Addendum No.: 2

Date Of Addendum: May 2, 2018

MacDougall Walker Correctional Institution
MacDougall Garage Repair/Rehabilitation
1153 East Street South
Suffield, CT
BI – JA-469

1 COATING AND PAVEMENT MARKING PLAN-LEVEL 1
 A1.6 0 4' 8' 16'
 SCALE: 3/32" = 1'-0"

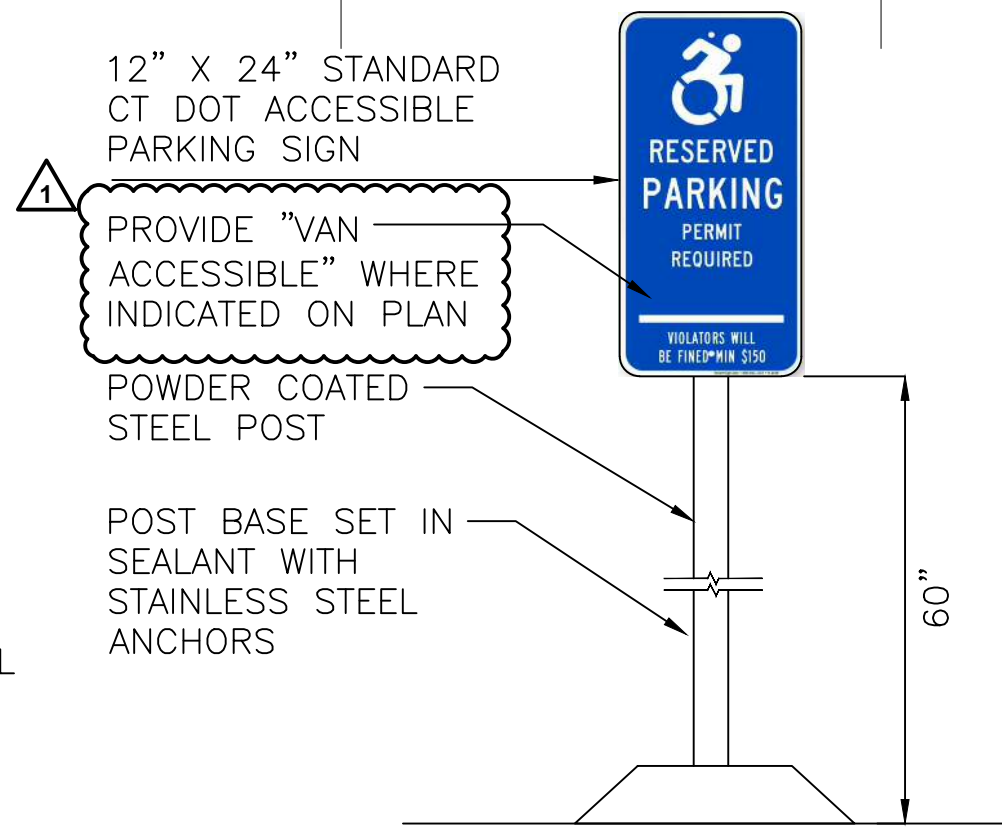
DESCRIPTION: Handicap parking layout was revised to include van accessible spaces. Quantity of standard accessible parking signs was revised from seven (7) to five (5) and two (2) van accessible signs were added.

2 TYPICAL ACCESSIBLE PARKING SIGN
 A1.6 NOT TO SCALE

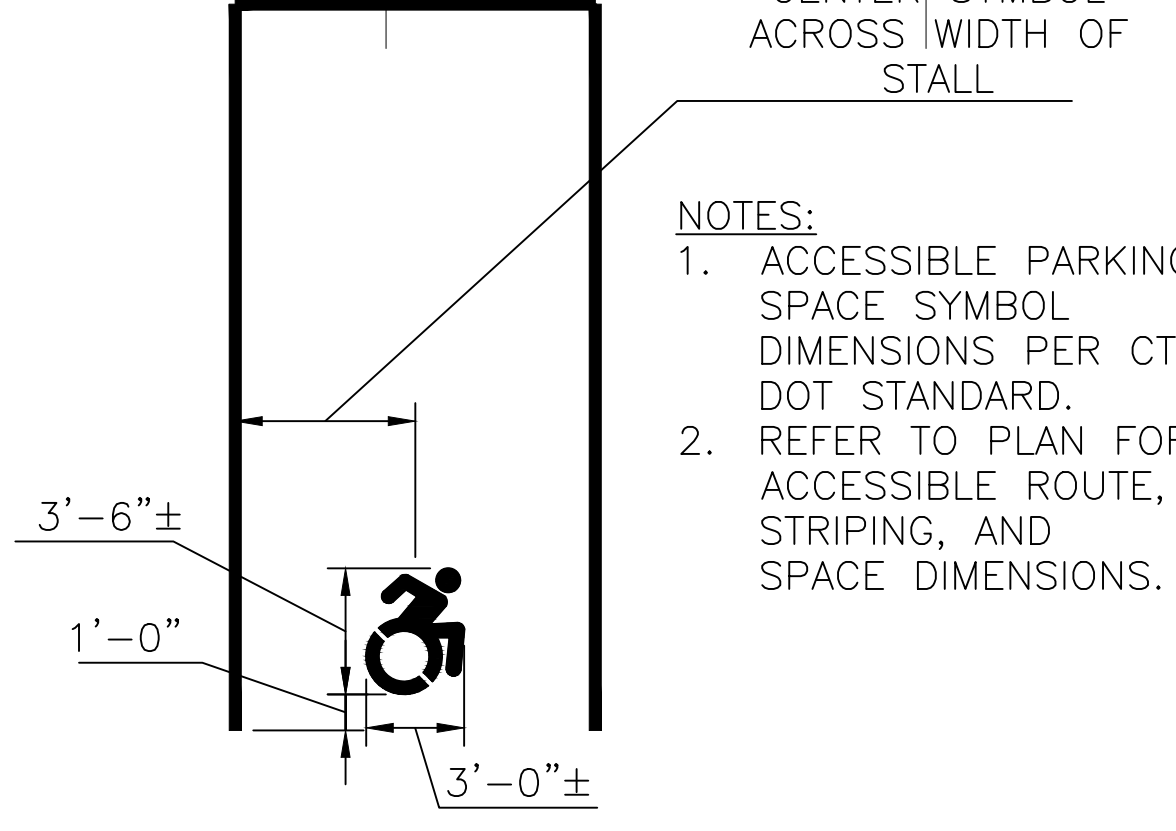
DESCRIPTION: Provide van accessible sign at van accessible spaces.

1 STAIR #1 LOWER LEVEL PLAN
 A4.1 0 4' 8'
 SCALE: 1/4" = 1'-0"

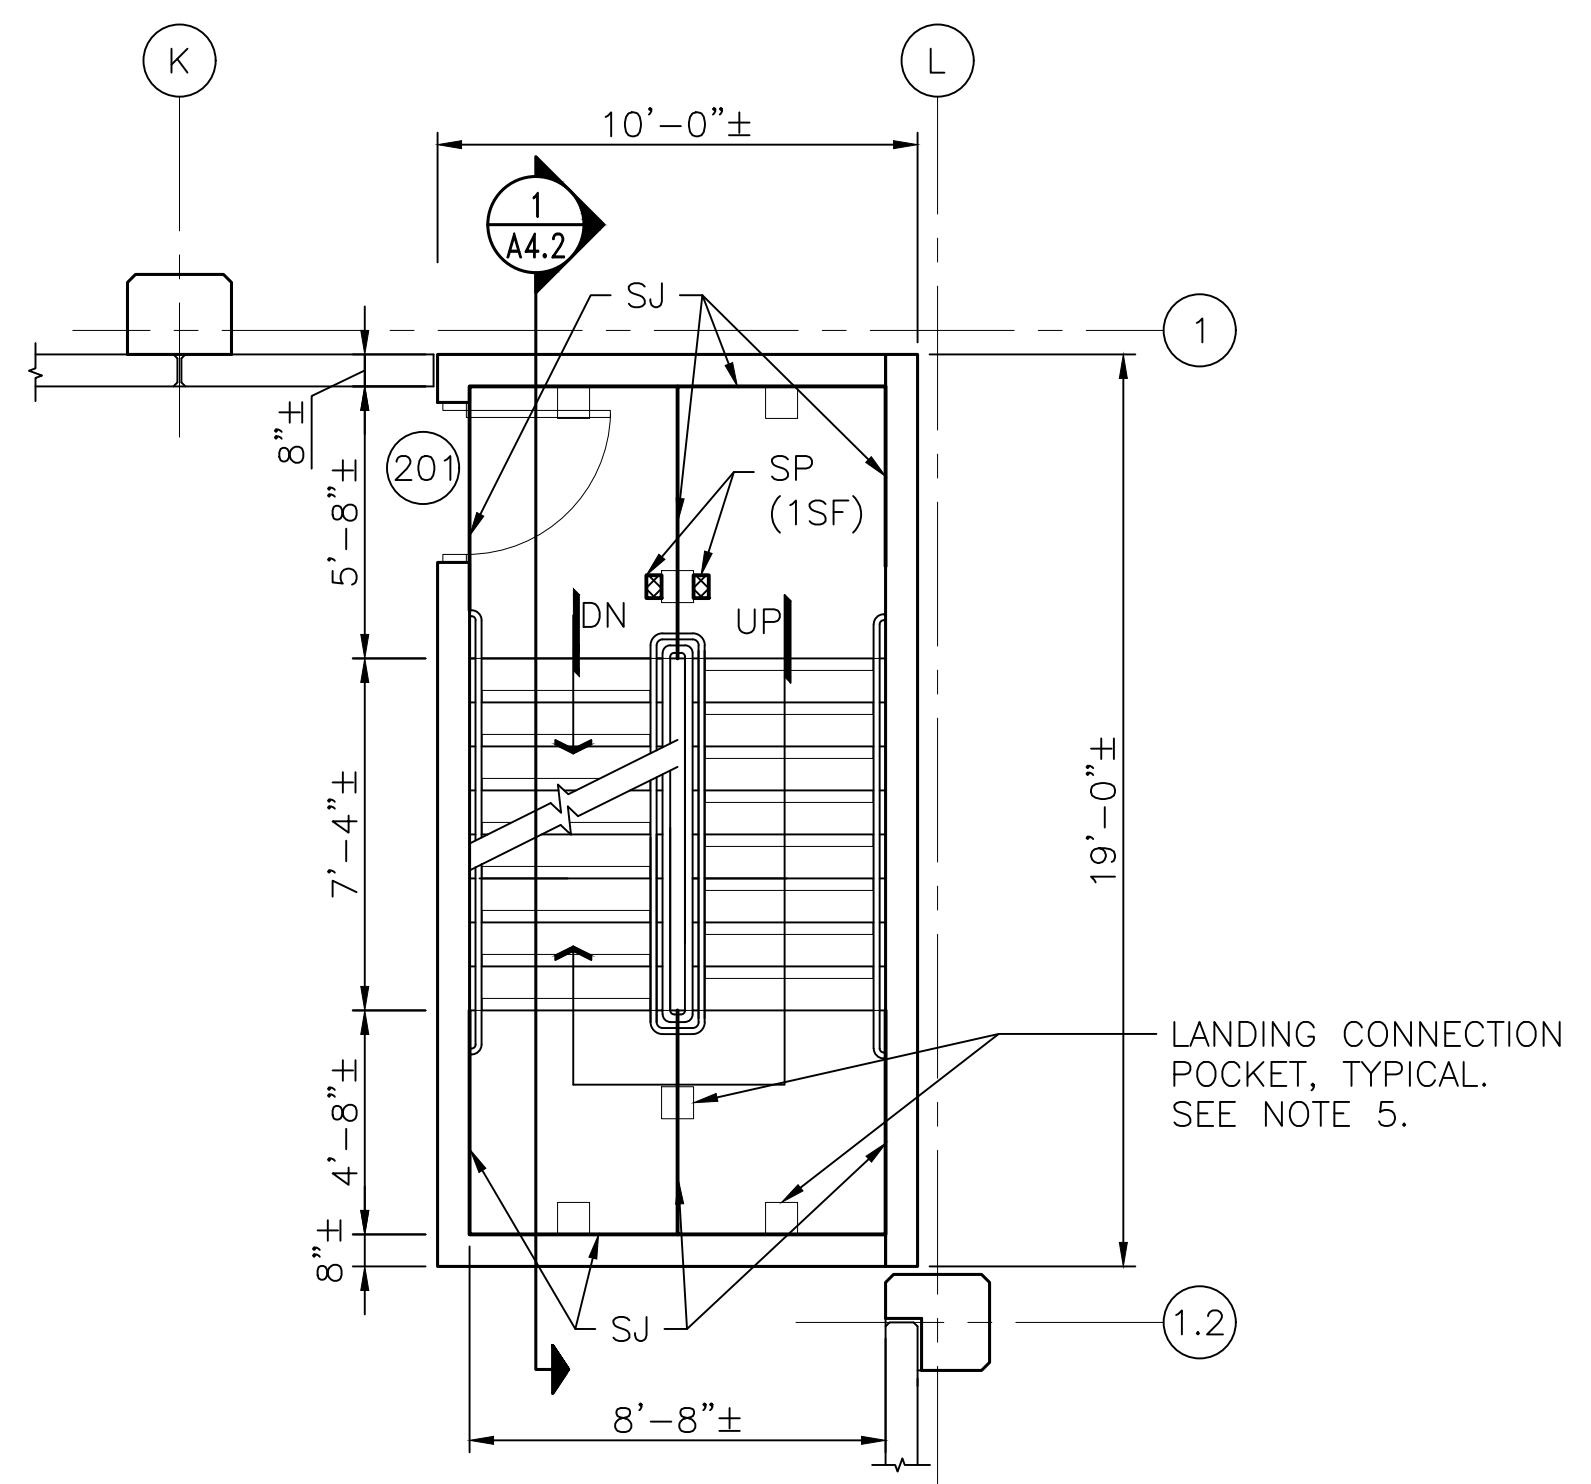
DESCRIPTION: Swing at door 102 (Lower Level of Stair #1) to be reversed.

3 STAIR #1 UPPER LEVEL PLAN
 A4.1 0 4' 8'
 SCALE: 1/4" = 1'-0"

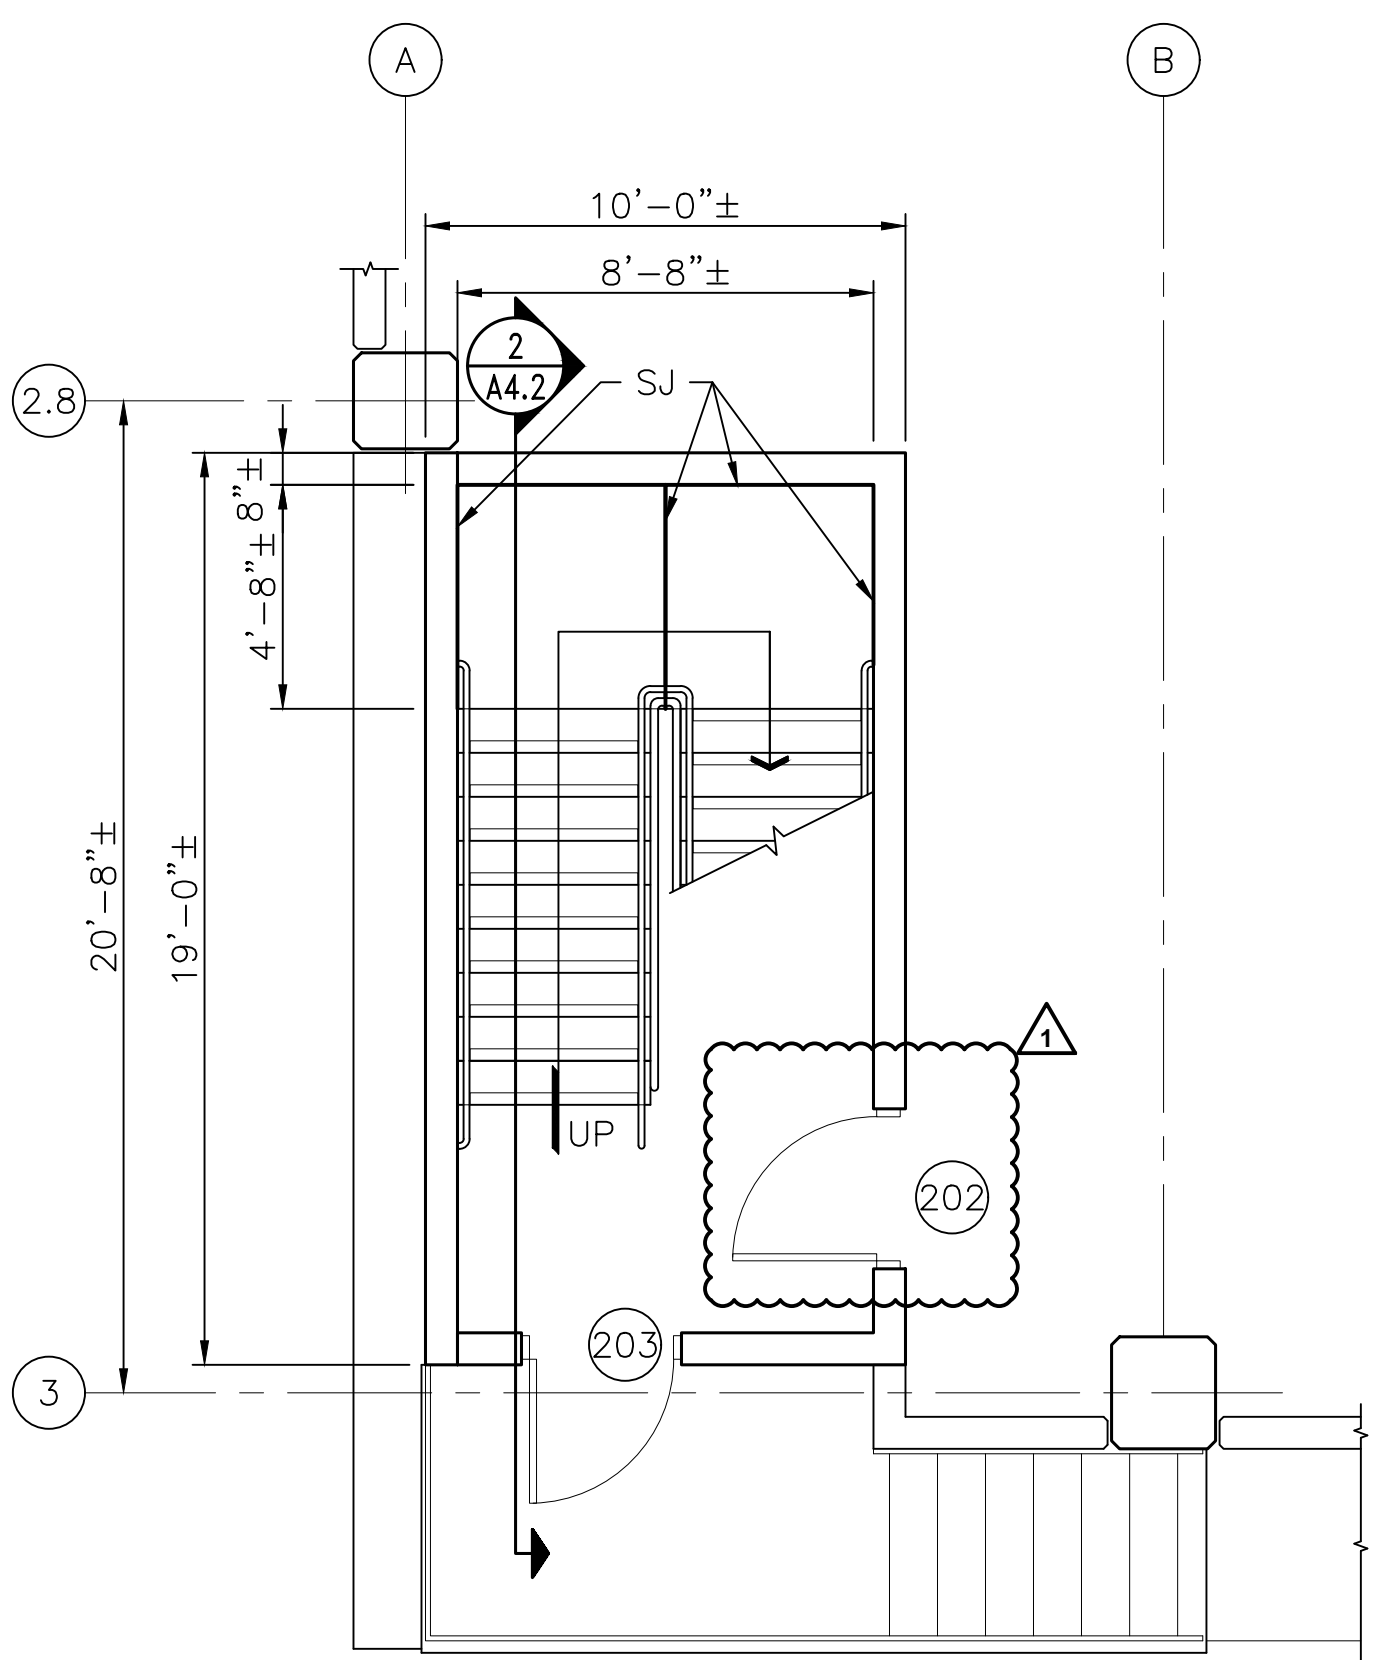
DESCRIPTION: The handrail at the top landing has been eliminated and a handrail extension in the direction of travel at the top of the stairs has been added.

4 STAIR #2 LOWER LEVEL PLAN
 A4.1 0 4' 8'
 SCALE: 1/4" = 1'-0"

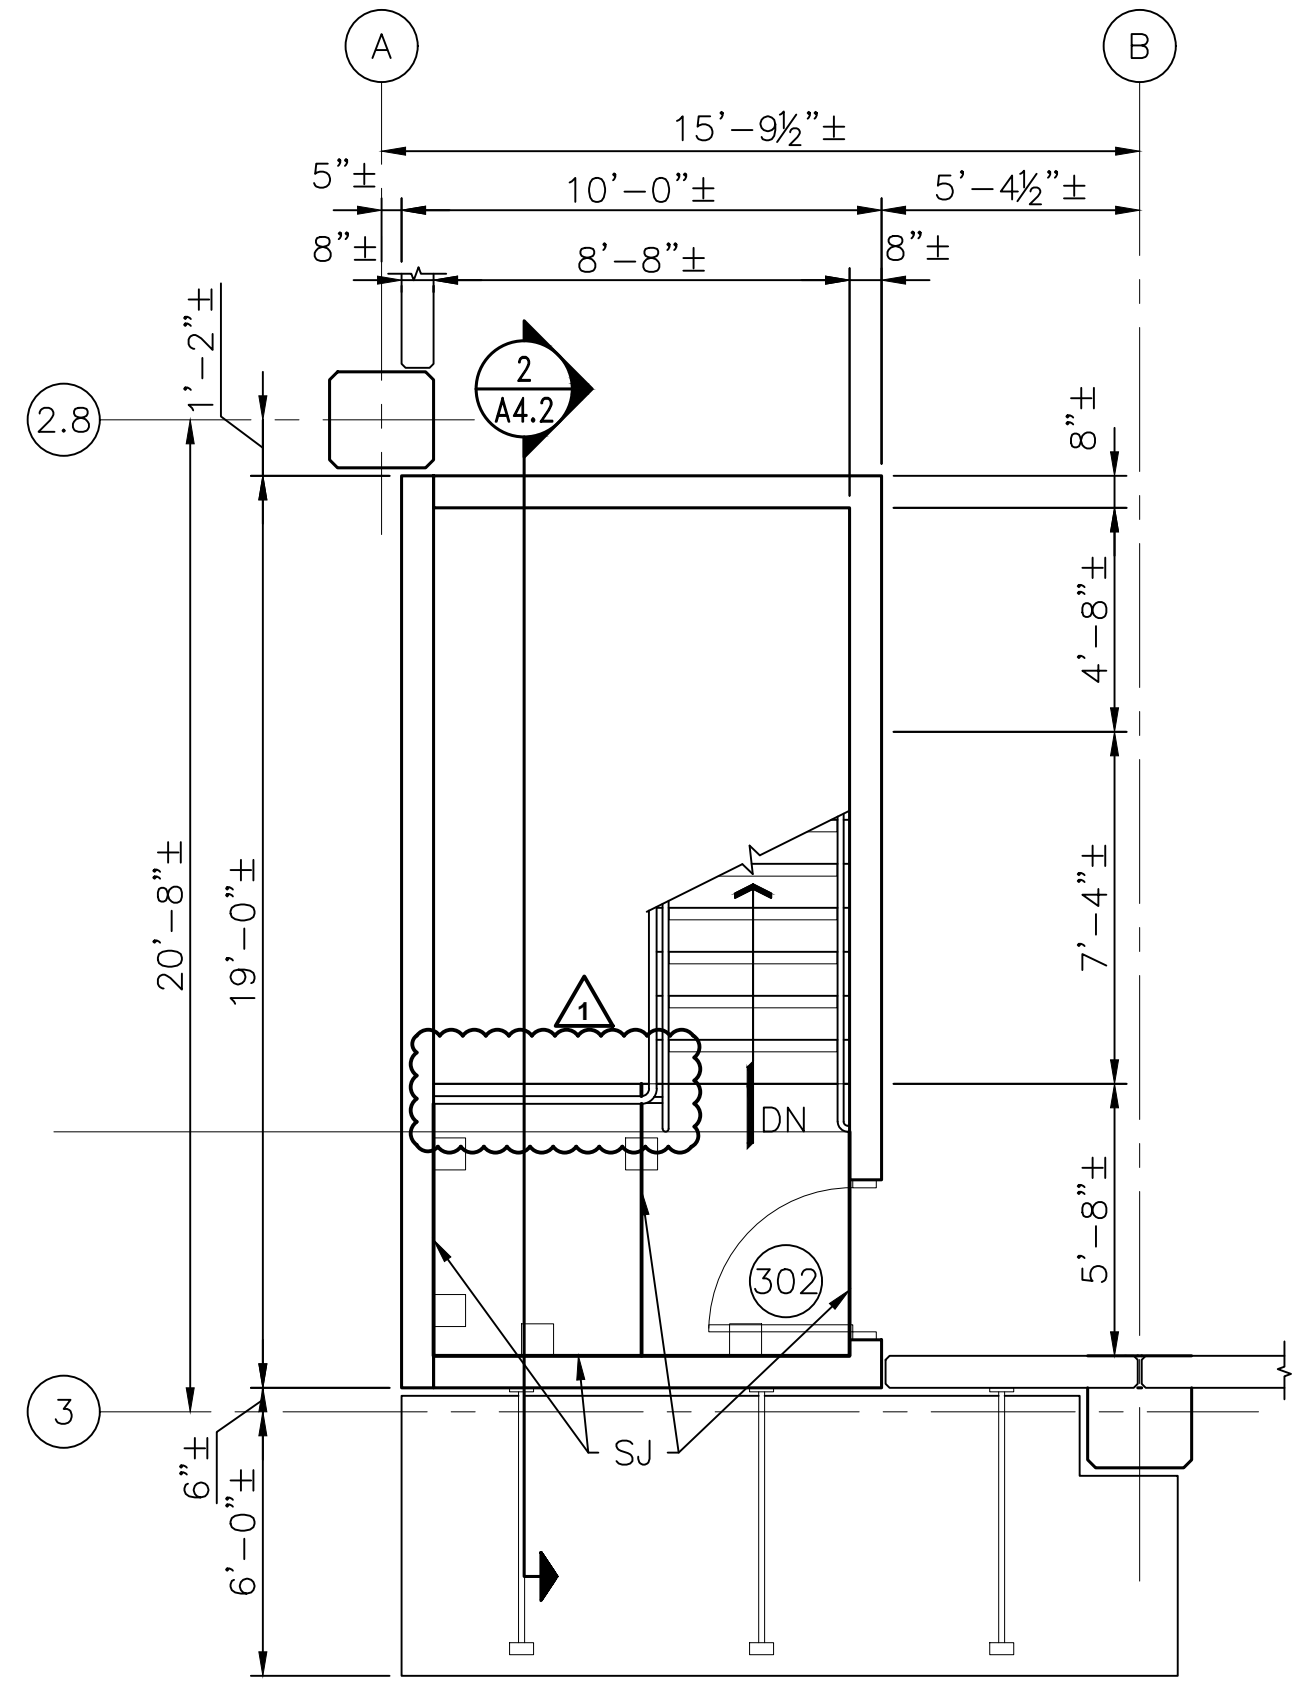
Clarification: Swing at door 202 (Lower Level of Stair #2) to be reversed.

5 STAIR #2 UPPER LEVEL PLAN
 A4.1 0 4' 8'
 SCALE: 1/4" = 1'-0"

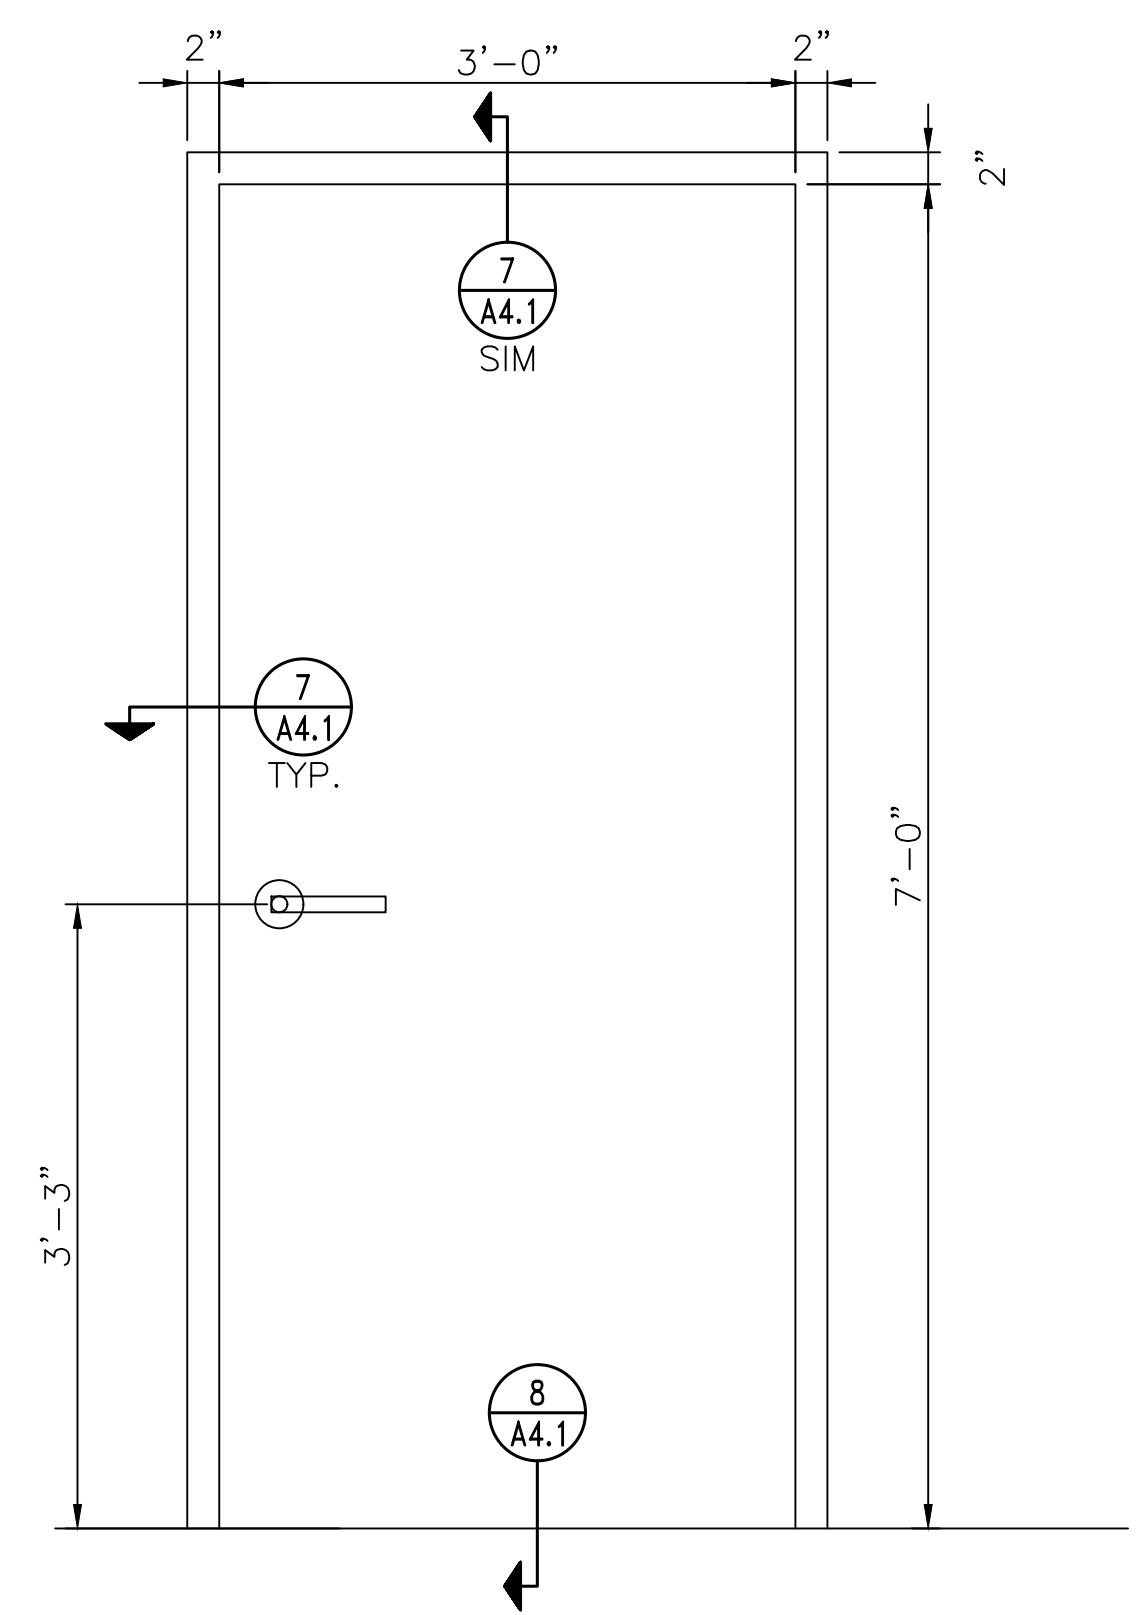
DESCRIPTION: The handrail at the top landing has been eliminated and handrail extension in the direction of travel at the top of the stairs has been added.
